Variance Letter of Explanation

Project Name (site name, subdivision name, or other) Johnson Deck Replacement

Pre-File Letter of Explanation in Support of Variance Application

Environmental Review Comments

LOCATION DRAWING
 LOT 7 PLAT 2
BROADVIEW ESTATES SOUTH
 SECOND DISTRICT
 ANNE ARUNDEL COUNTY, MARYLAND
 SCALE: 1" = 50' AUGUST 2024
 PROJECT #68257
 F/N: BROADVIEWESTATESSOUTH-P2-L7

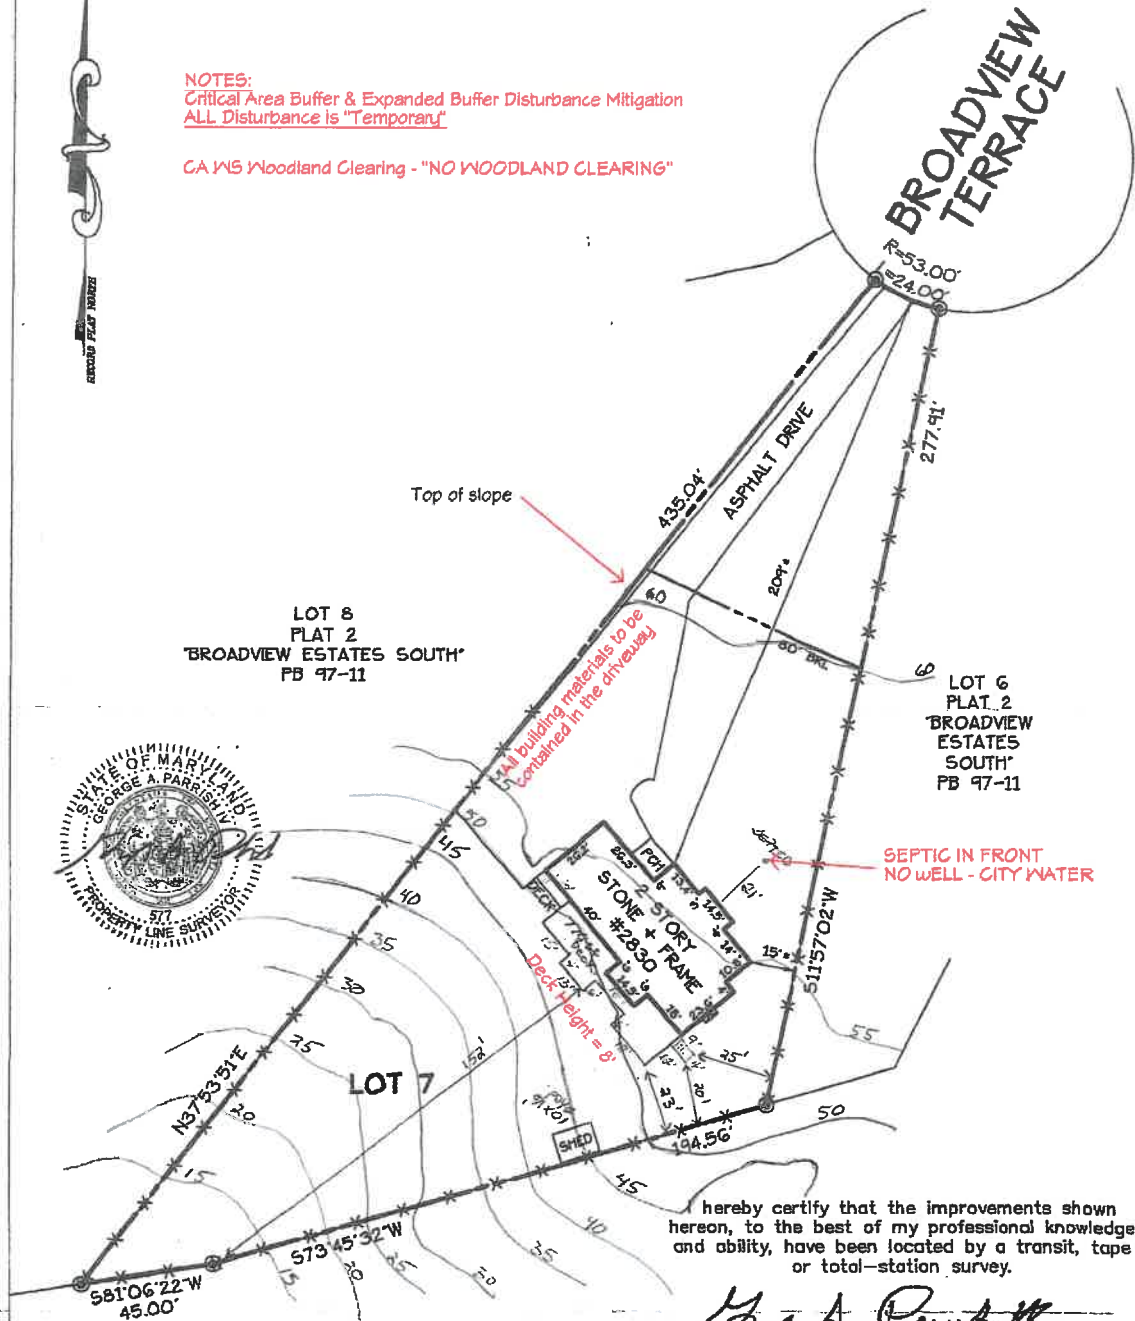
A review of 2024 aerial images shows the proposed scope of work to be located in or near areas of vegetation (trees, shrubs). Please revise the critical areas worksheet to indicate how much clearing will be related to the scope of work. If it is determined that no clearing will be required, then please provide a note on the site plan indicating no woodland clearing.

Revise the Administrative Site Plan to: include the height of the deck and screen porch, along with the length and width dimensions on the site plan; clearly identify and label the topo on the site plan; clearly indicate the top of slopes and the 100ft buffer/expanded buffer.

NOTES:
 Critical Area Buffer & Expanded Buffer Disturbance Mitigation
 ALL Disturbance is "Temporary"

CA WS Woodland Clearing - "NO WOODLAND CLEARING"

To address the Critical Area Buffer & Expanded Buffer Disturbance Mitigation concern, all disturbance will be temporary as there will be no changes to the impervious coverage of the property.

To address the CA WS Woodland Clearing concerns, there will be NO WOODLAND CLEARING of any kind.

Deck Replacement Project for Louis & Sheila Johnson

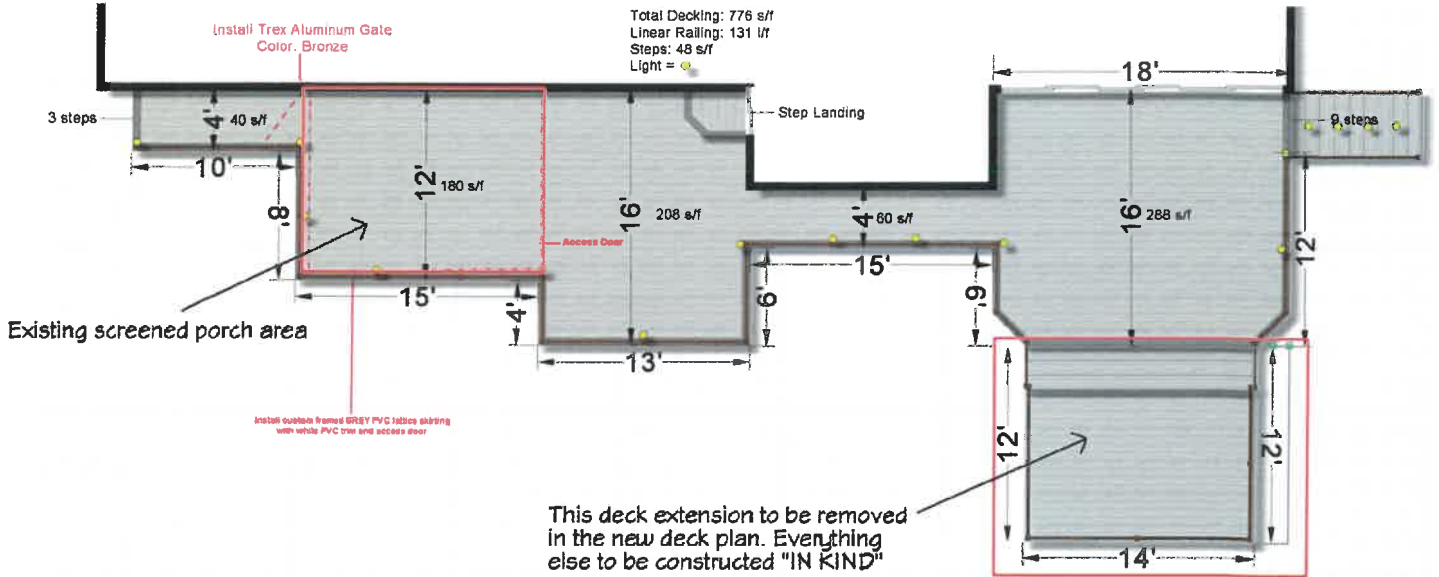
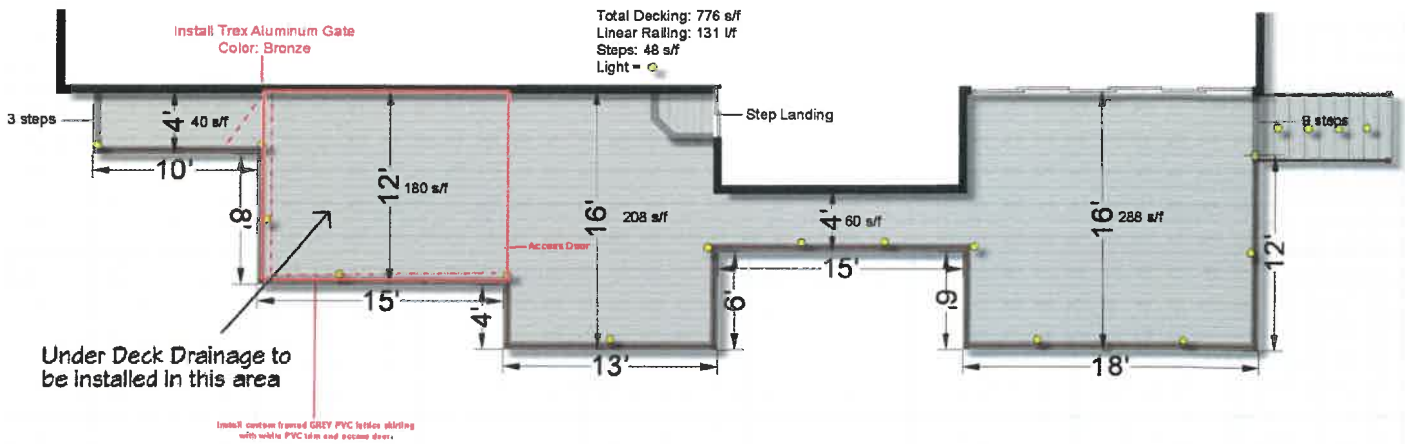
This deck extension & Pergola
to be removed and not replaced

This deck extension and pergola to be removed, and not replaced
